1986 - 1987 Corvette: Service Bulletin: Convertible Top Number 5 Bow Weatherstrip Loose

Model Year: 1986-1987 Corvette Convertible
Subject: Convertible Top Number 5 Bow Weatherstrip Loose
Source: Chevrolet Dealer Service Bulletin
Bulletin Number: 87-148, Number 10
Date: May, 1987

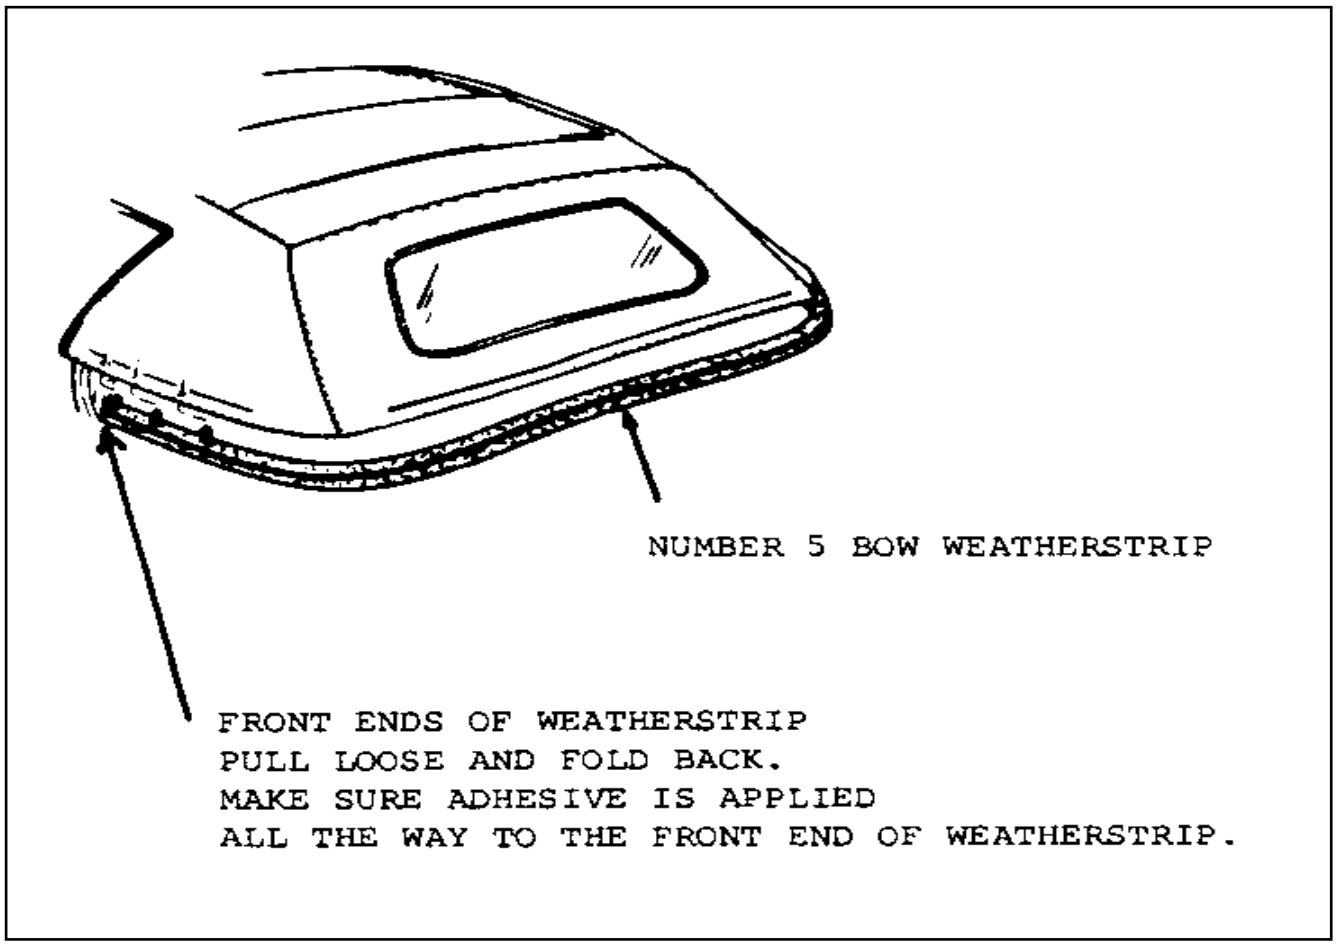
Comments have been reported that on some Corvette convertibles, the number 5 bow weatherstrip pulls loose from the bow at the front ends. Effective with start of 1987 production, the source used an adhesive which eliminated this problem on 1987 vehicles.

Field repairs can be accomplished by gluing the weatherstrip ends down with 3M weatherstrip adhesive, P/N 08011, or P/N 12345096-7 weatherstrip adhesive. (See illustration). Before applying adhesive wipe the weatherstrip with alcohol or all purpose adhesive cleaner to remove any mold release compound. Care should be taken to make sure the adhesive is applied all the way to the extreme forward ends of the weatherstrip. Also, be sure the plastic nails are installed properly. If the weatherstrip is damaged, it will have to be replaced.
